# Chelan County Public Works Department

January 16, 2026  
**Addendum No. 4**  
Page 1 of 6

## RE: CRP 650, Totem Pole Road Phase I Road Improvement Project

Drawing No.  
MD1  
Sheet No.  
38  
50  
of Total

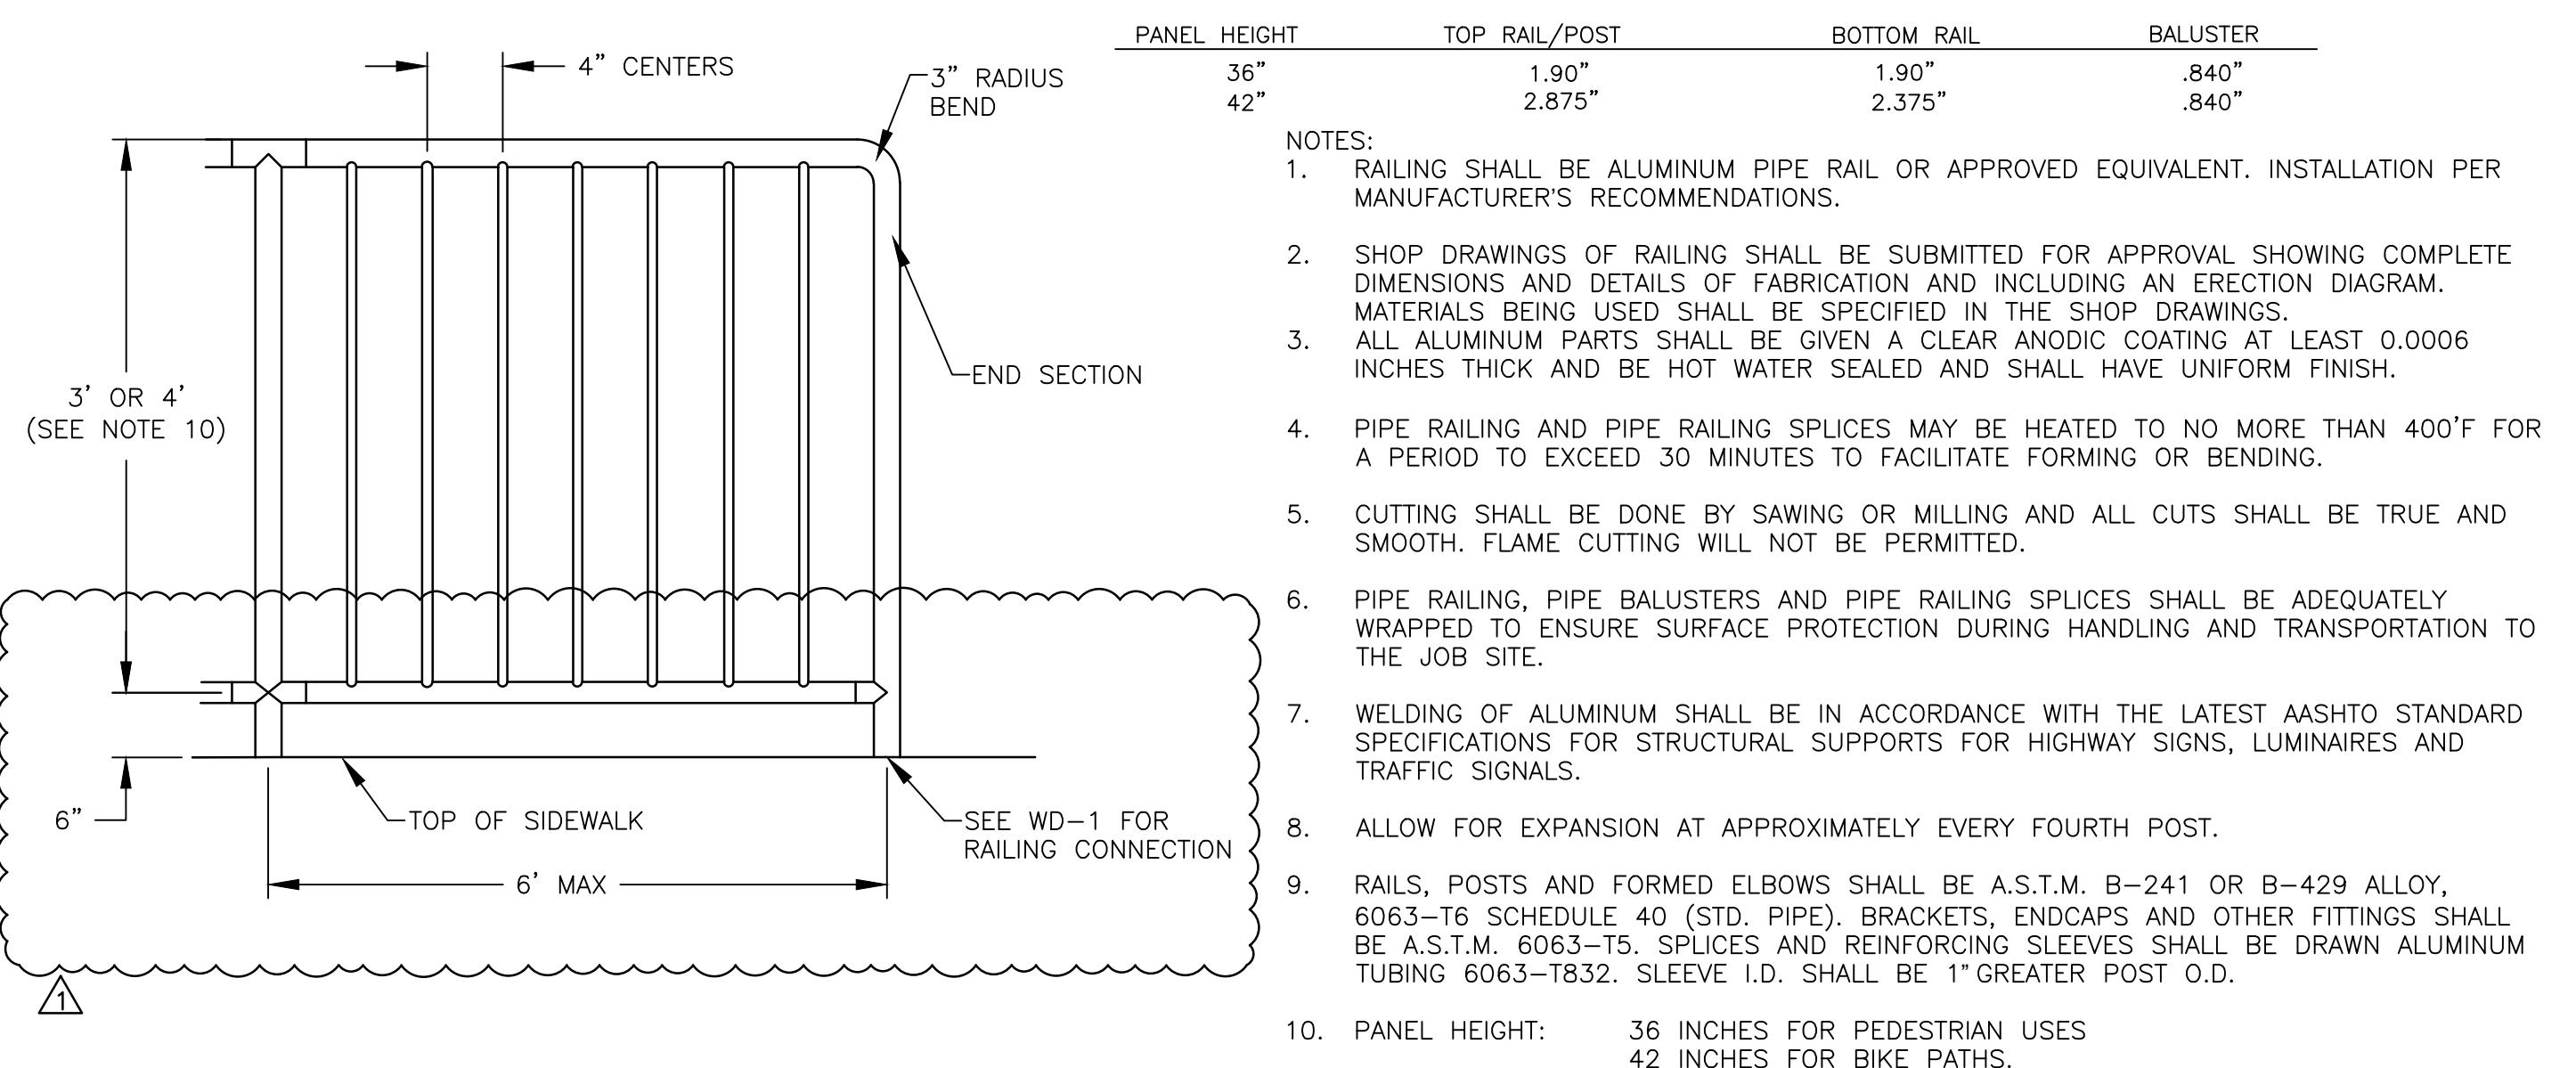
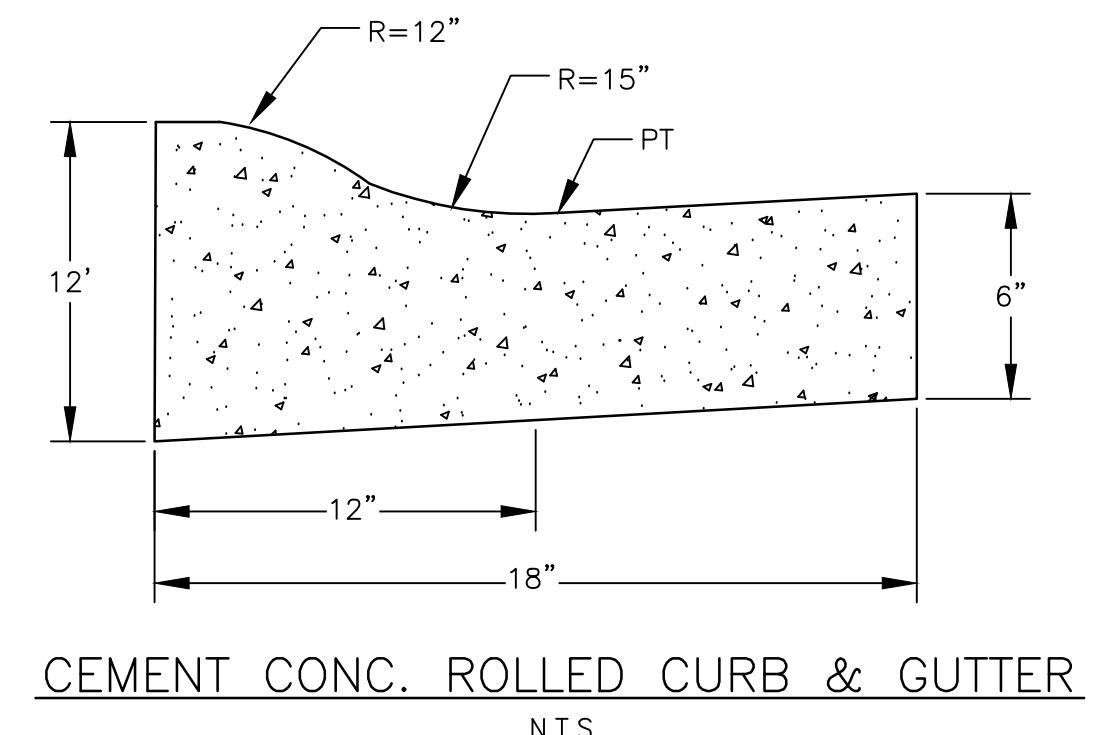
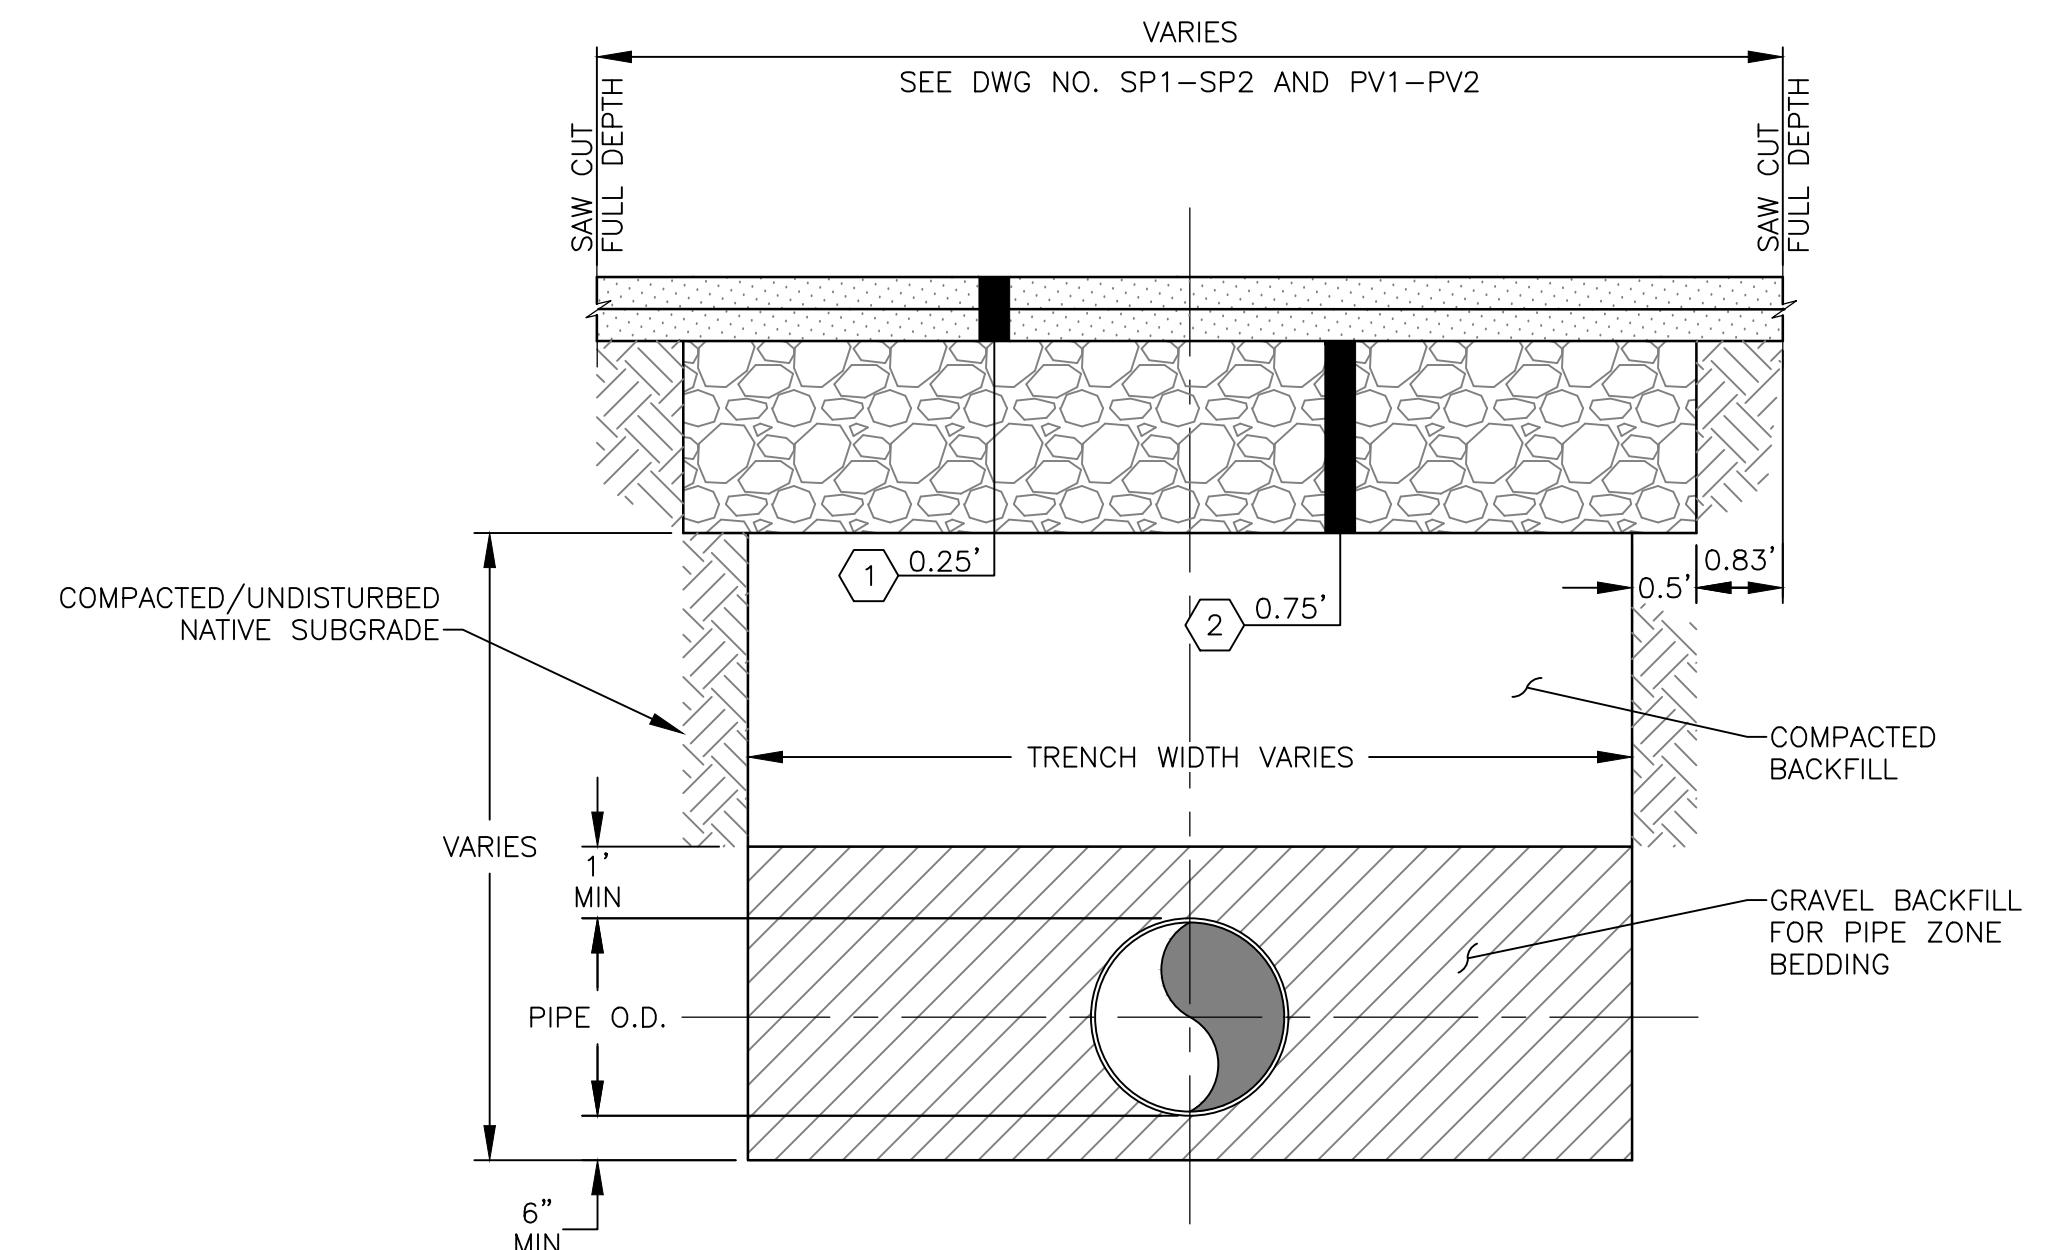
1. Remove the following plan sheets and replace in their entirety with attached Addendum No. 3 Plan Sheets:

WP1 (Supersedes note change from Addendum 1), WD1, MD1

1. Question: Multiple Contractors and Suppliers asked for clarification regarding retaining wall type, retaining wall cap, and mounting the pedestrian railing to Wall #1. Additionally, Contractors requested an alignment for Wall #1.

Answer: See included changes to Special Provisions and attached, revised, Plan Sheets for clarifications.
